[Docket No. 2001-SW-40-AD; Amendment 39-13022; AD 2002-13-05 R1]

Airworthiness Directives; MD Helicopters, Inc. Model 369D, 369E, 369F, and 369FF Helicopters

ACTION: Final rule.

2002-13-05 R1 MD Helicopters, Inc.: Amendment 39-13022, Docket No. 2001-SW-40-AD.
Revises AD 2002-13-05, Amendment 39-12793.

Figure 1 - Inspection Location

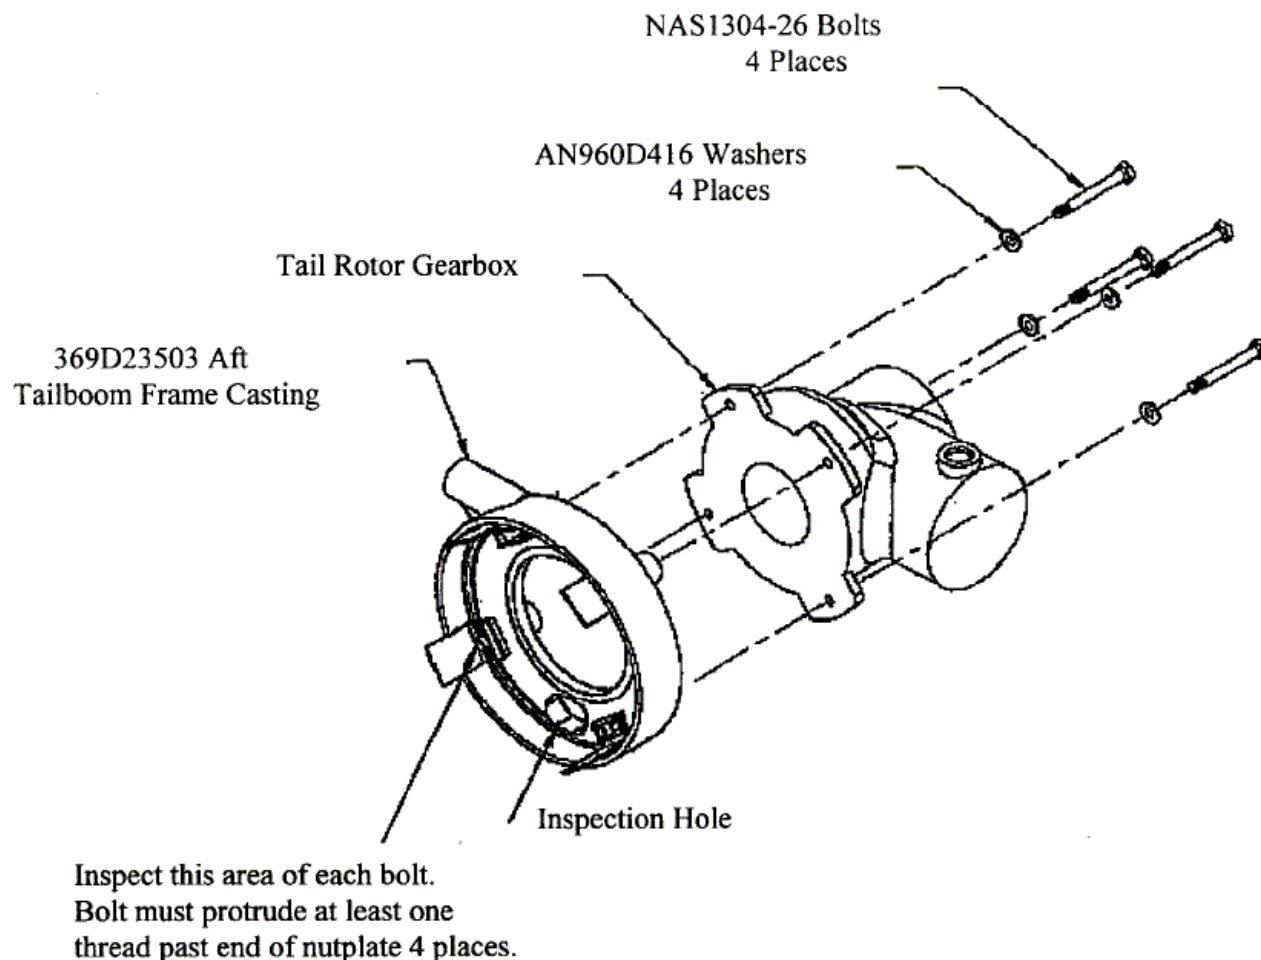
- (a) Within 25 hours time-in-service (TIS):
 - (1) For each tail rotor gearbox attaching bolt (bolt):
 - (i) Determine the part number (P/N).
 - (ii) If the P/N cannot be determined or if the bolt is not P/N NAS1304-26, before further flight, replace the bolt with bolt, P/N NAS1304-26.
 - (iii) Torque the bolt to 100-110 in-lbs and apply a slippage mark.
 - (2) Remove the tailboom control rod and determine the number of bolt threads protruding from each nutplate on the internal surface of the aft tailboom frame casting, P/N 369D23503, as shown in Figure 1 of this AD. At least one thread must protrude. If more than four threads protrude, add an additional washer, P/N AN960D416, under the bolt head. Torque the bolt to 100-110 in-lbs, and reapply a slippage mark. See Figure 1:

(b) Between 2 and 10 hours TIS after accomplishing the requirements of paragraph (a) of this AD, inspect the torque on each bolt by applying 100 in-lbs. If any bolt movement occurs, retorquing the bolt to 100-110 in-lbs. Reapply a slippage mark to the bolt regardless of the outcome of the torque test. Reinspect the torque between 2 and 10 hours TIS thereafter until no bolt movement occurs.
